Service Bulletin

S.B. No: 169

Title: **INSPECTION OF ENGINE INTAKE DUCT MESH AND ALTERNATE AIR DOOR**

Applicability: T67M, T67M-MkII

FIG. 1 AIR INTAKE DUCT T67M-50-101

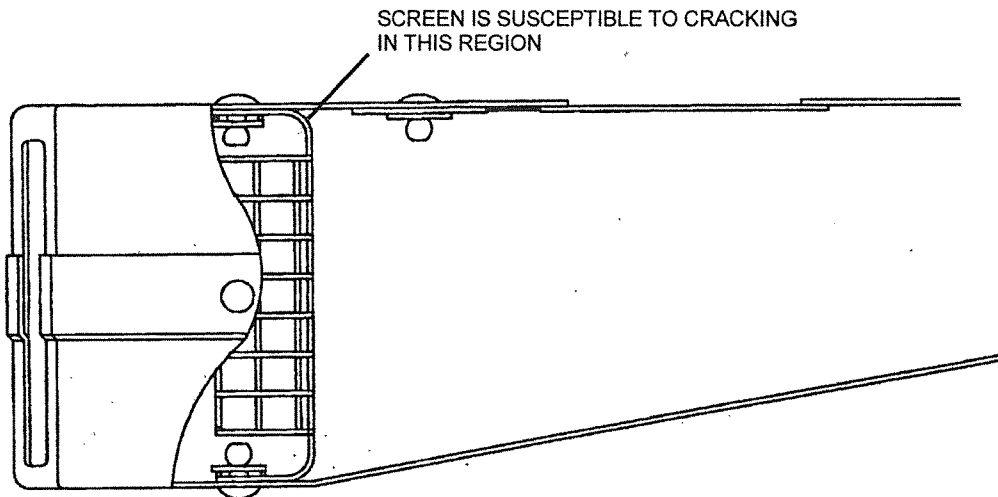
Cases have been reported of both the engine air intake duct mesh cracking and of alternate air door rivets loosening. These cases have been reported only where T67M-50-101 intake ducts have been fitted: however this Service Bulletin also relates to T67M-50-103 intake ducts.

8. Should both inspections at paragraphs 4, 5 and 6 be considered to be satisfactory, then proceed as follows:
- i) If intake duct assy is T67M-50-103 (Ref Figure. 2) no further action is required. Annotate logbook "SB169 complied with".
 - ii) If intake duct assy is T67M-50-101 (Ref Figure 1) then it is necessary to repeat inspection stages 4, 5 and 6 detailed within this Service Bulletin SB169 every 50 hrs flying hours, until Mod M760B air intake repair is invoked. When Mod M760B is incorporated annotate logbook "Mod M760B incorporated".
